March 1, 1989

DRAINAGE PLAN FOR NOCTURNAL EXHIBIT PHASE IV

RIO GRANDE ZOOLOGICAL PARK (K-13/D25) ENGINEER'S STAMP DATED FEBRUARY 22, 1989

## DRAINAGE PLAN

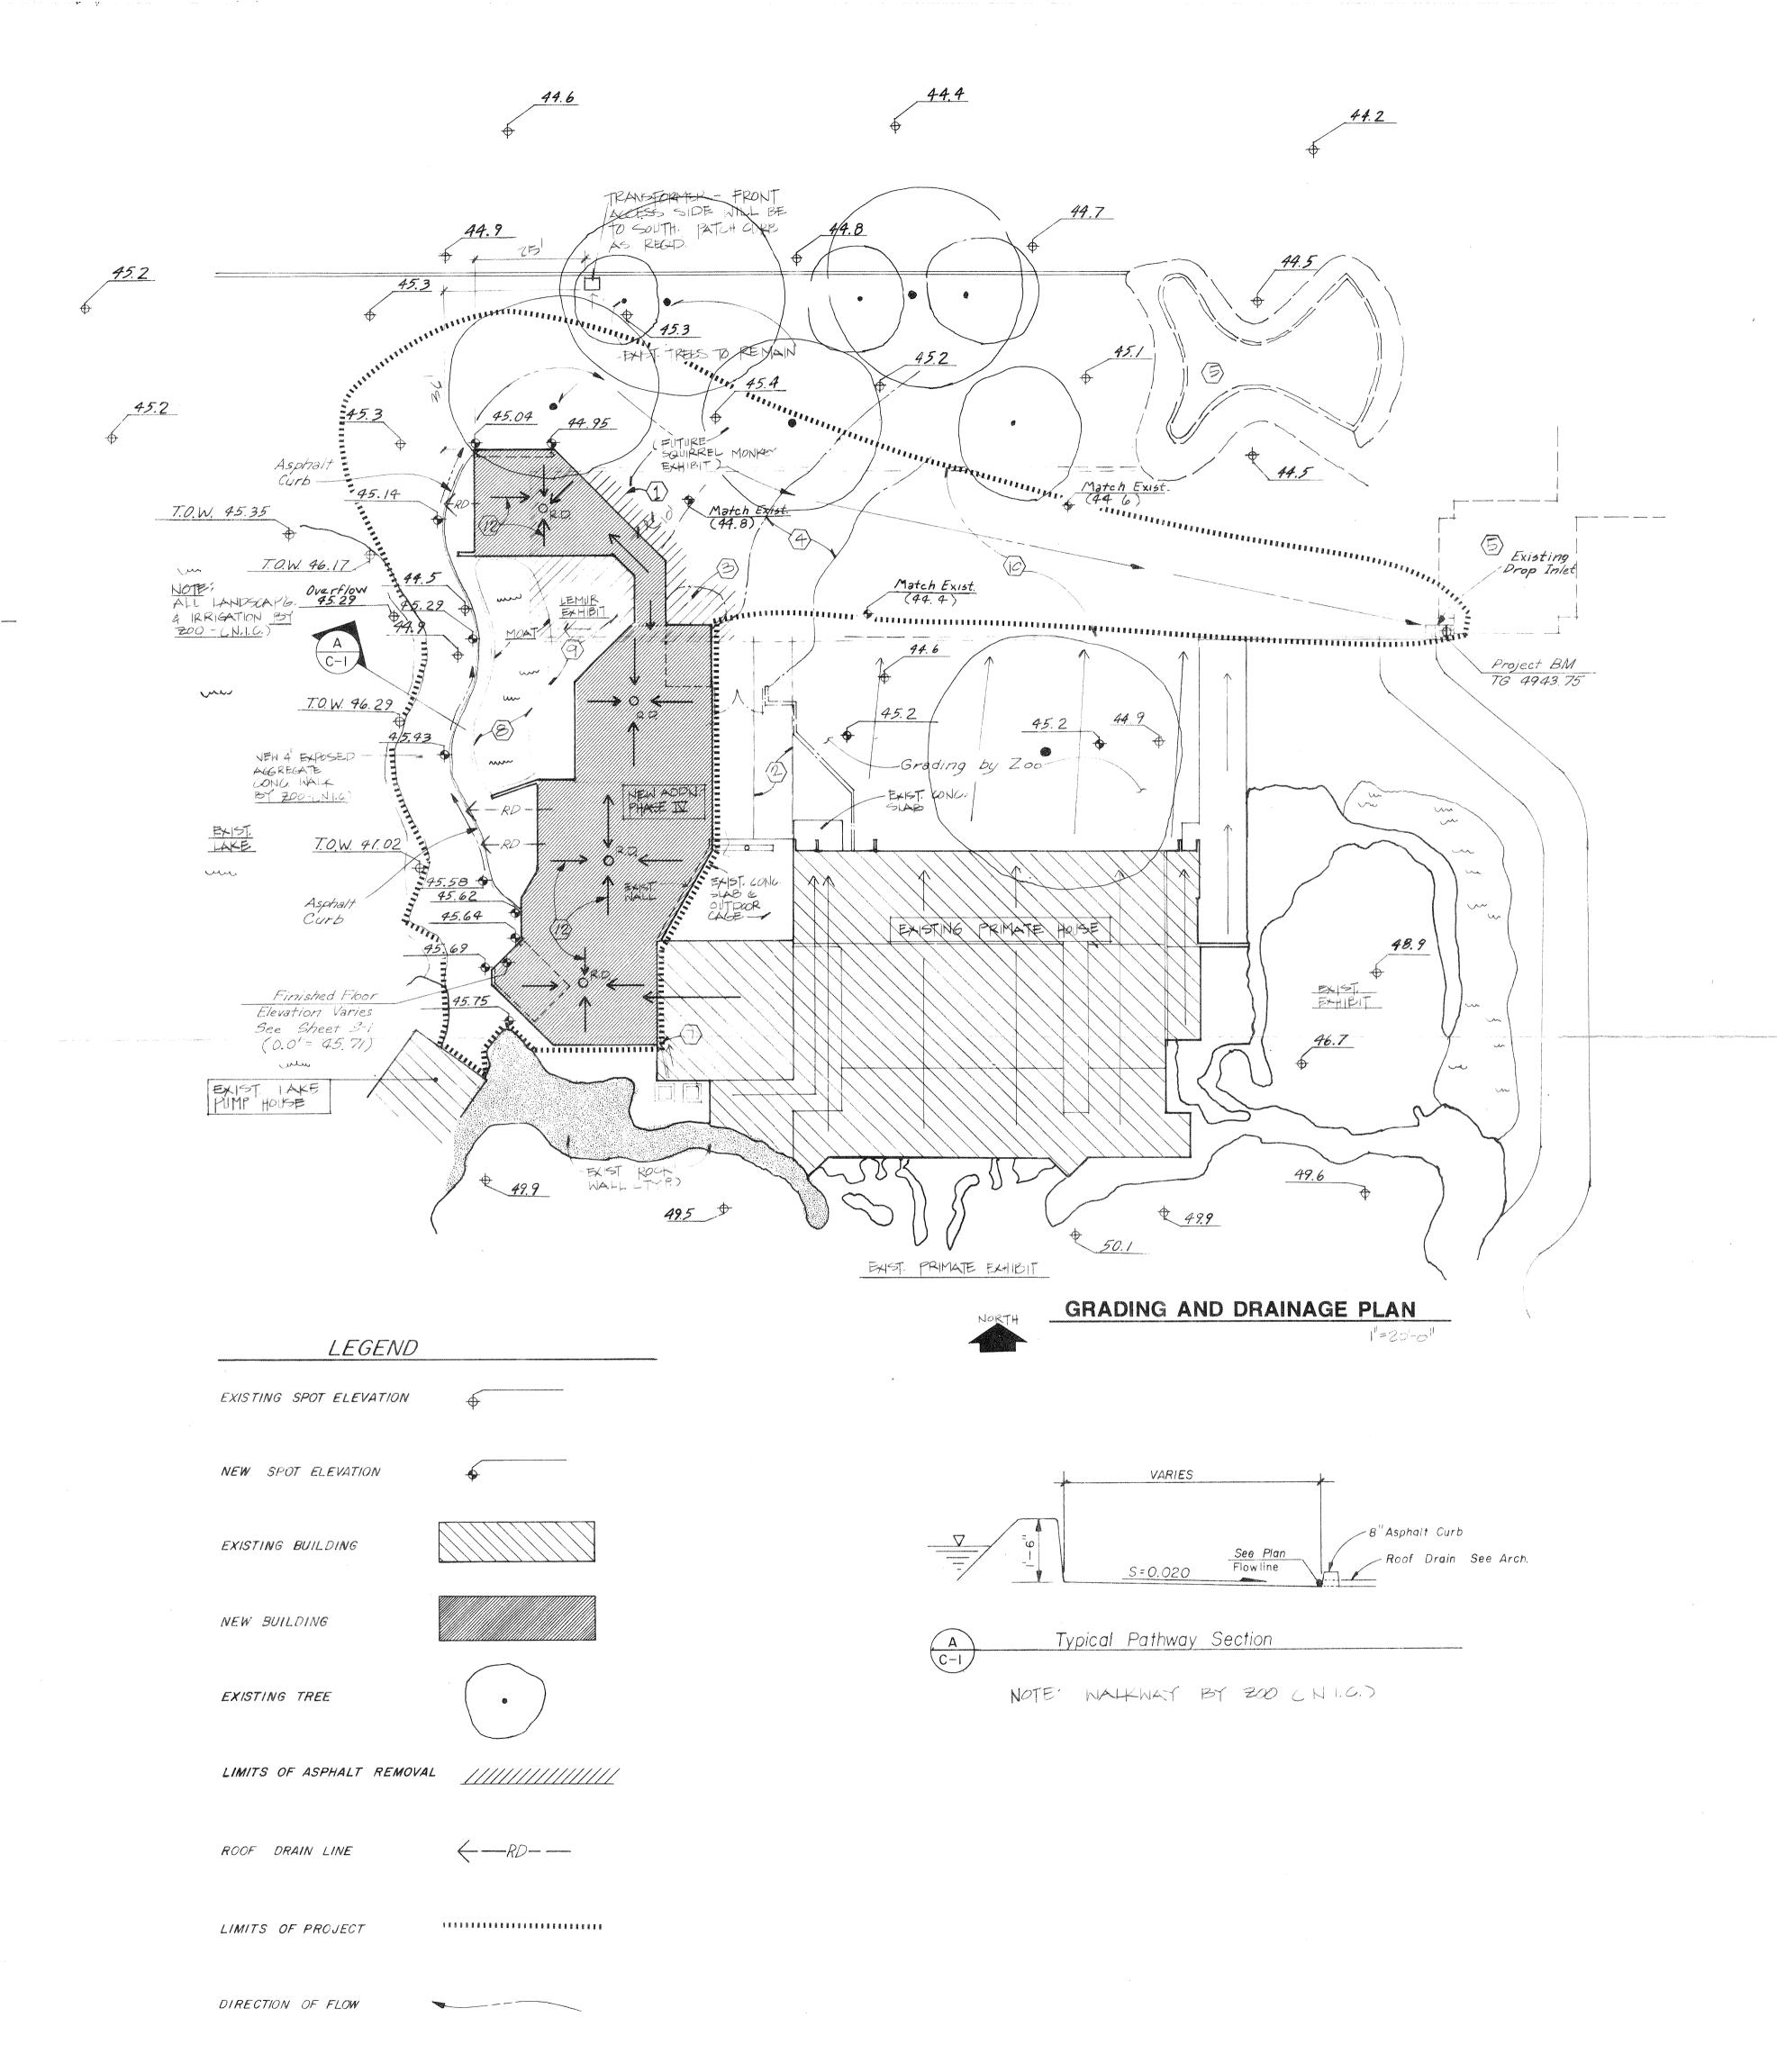
Based on the information provided on your submittal of February 22, 1989, the above referenced plan is approved for Building Permit.

Please attach a copy of this plan to the construction sets prior to sign-off by Hydrology.
